City of Albuquerque Environmental Planning Commission

Staff Report

CASE #: SP-2026-00044

CASE SUMMARY: This request is a Site Plan – EPC for the Albuquerque Bernalillo County Water Utility Authority (ABCWUA) to develop a water reuse system (i.e., major utility use) in the Mesa del Sol Community Master Plan Employment Center I boundaries.

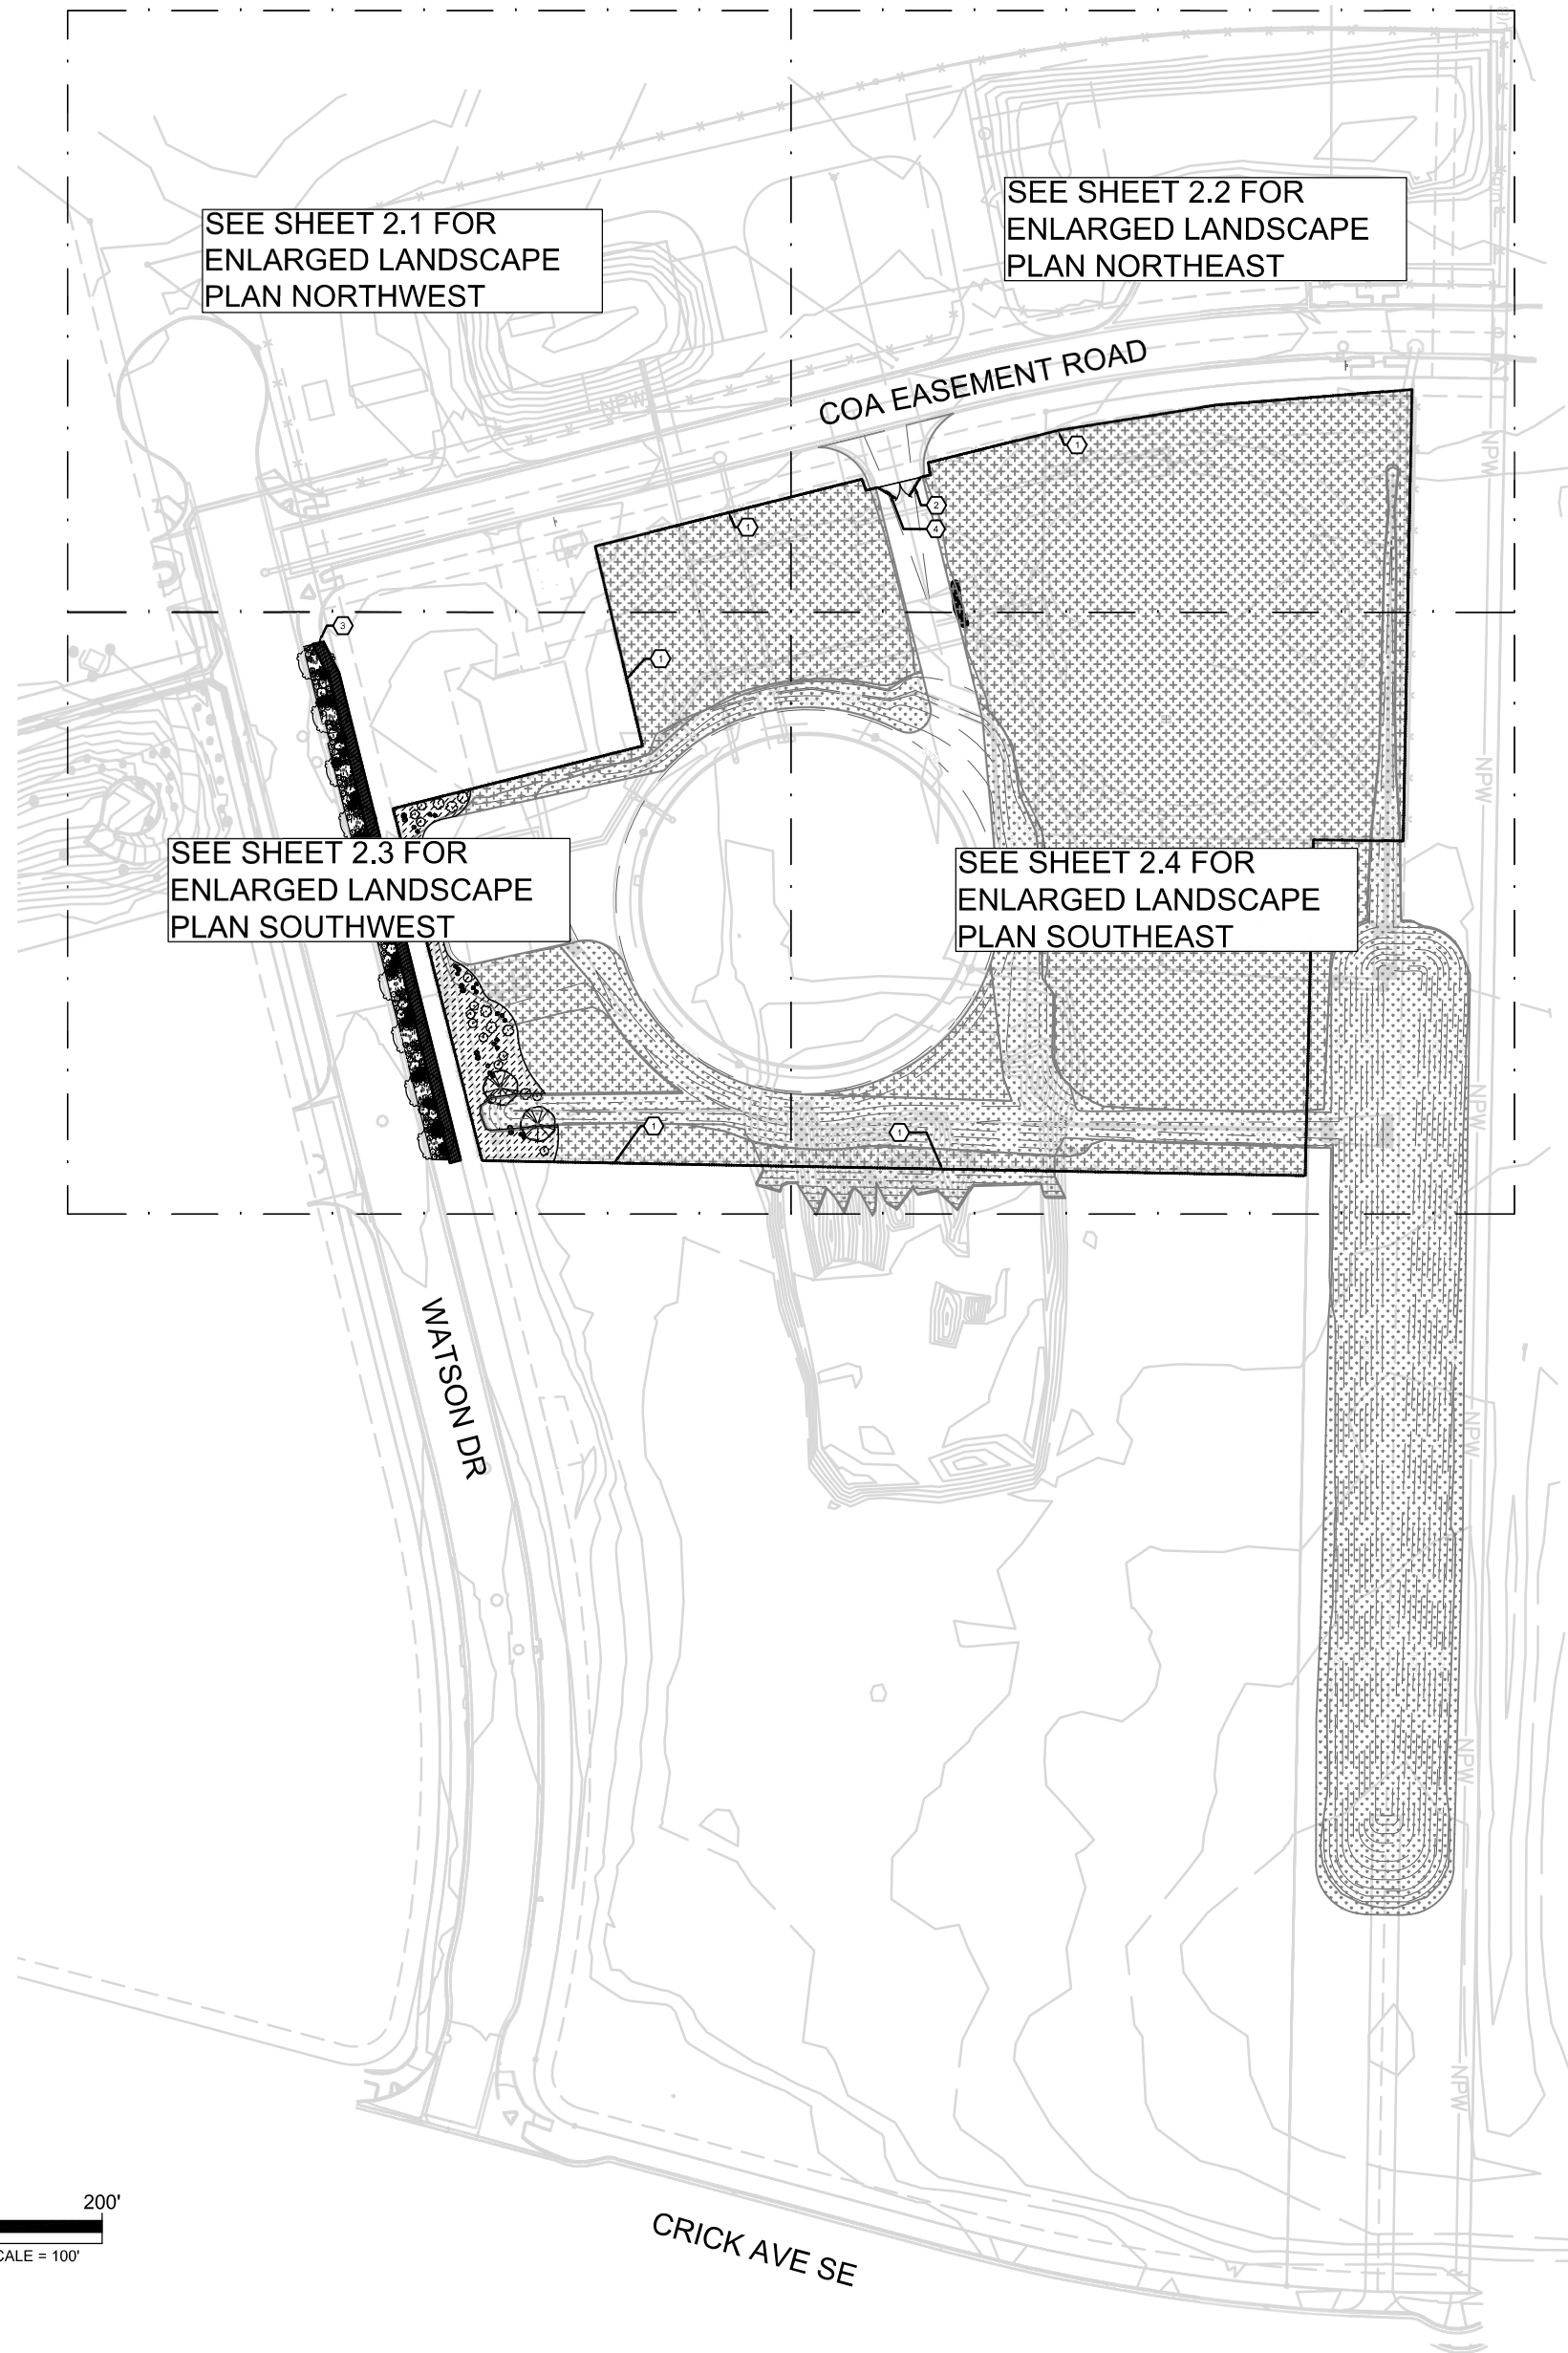
- Plant Schedule: Chitalpa is not recommended pursuant to the [Official Albuquerque Plant Palette and Sizing List](#), please replace with an appropriate alternative.
- Exhibit 2.0 appears to be different than what was submitted to ARC, please ensure any changes requested from ARC are incorporated into this new proposed Site Plan.
- Consider condensing the Landscaping sheets if possible. Some sheets, such as Exhibit 2.1 show a small portion of the project area and doesn't provide additional/new information.

- The Pink Dawn Chitalpa has been replaced with Sensation Box Elder, and the required street tree frontage and landscape calculations have been provided on the updated Sheet 2.0.
- The grading and drainage comments on Sheet 3.0 have been addressed.
- The utility plan comments on Sheet 5.0 have been addressed, including confirmation regarding the storm drain in the COA Easement Road and the confirmation that the Fidelity Pond has capacity for the intended tank drainage under the operating conditions described in the response.

WATER AUTHORITY CONSTRUCTION PROJECT NO.	ZONE MAP NO.	SHEET C-304A
---	-----------------	-----------------

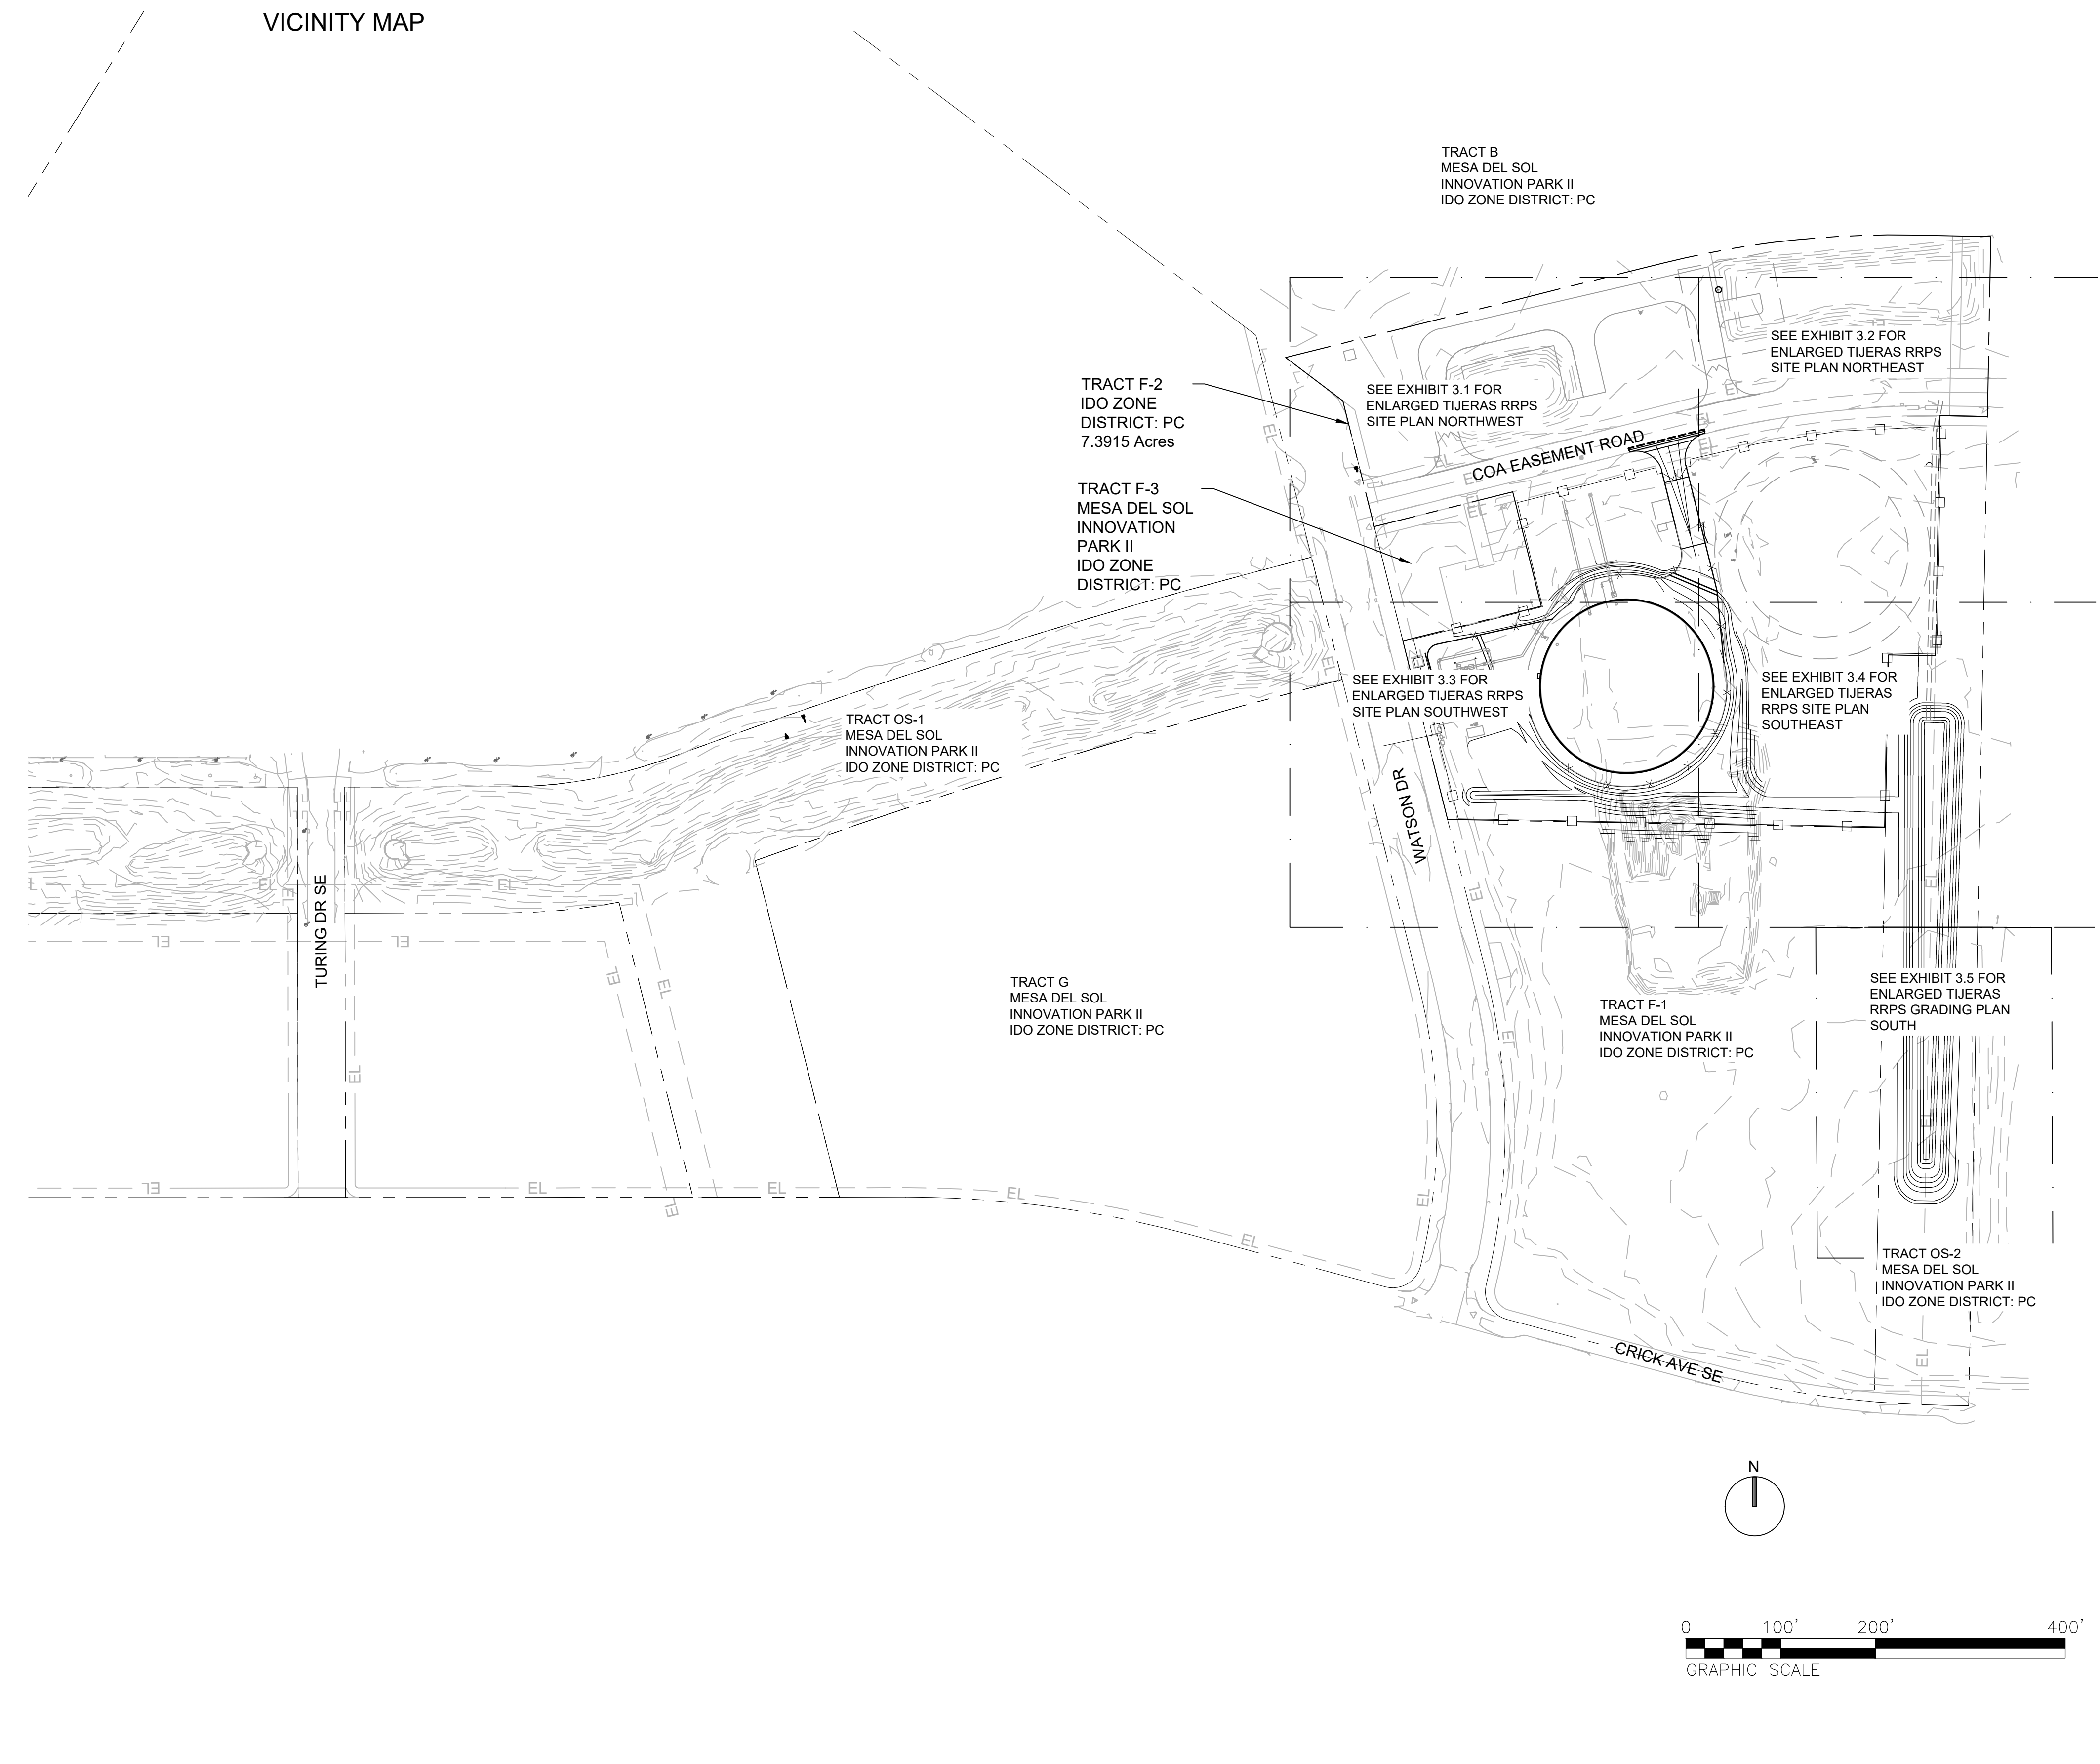
2. Please provide the Benchmark information (location, description and elevation) for the survey contour information provided.	Benchmark information, including control points, benchmarks, and brass cap locations, has been added to Sheet C-304. In addition, new Sheet C-304A has been added and includes a coordinate table listing Point ID, latitude, longitude, northing, easting, elevation, and

Comment	Jacobs Response
	point descriptions, as well as the Surveyor's Control Notes.
3. Please provide a Vicinity Map. This can be downloaded in pdf format from the City of Albuquerque's website.	An IDO Zone Atlas Map for Q-16-Z has been added to new Sheet C-304A to provide vicinity information for the project site.

4. Please provide the FIRM Map and flood plain note with effective date.	FEMA FIRM Map No. 35001C0363G, with an effective date of September 26, 2008, has been added to Sheet C-304A. The associated floodplain information and note have also been included.
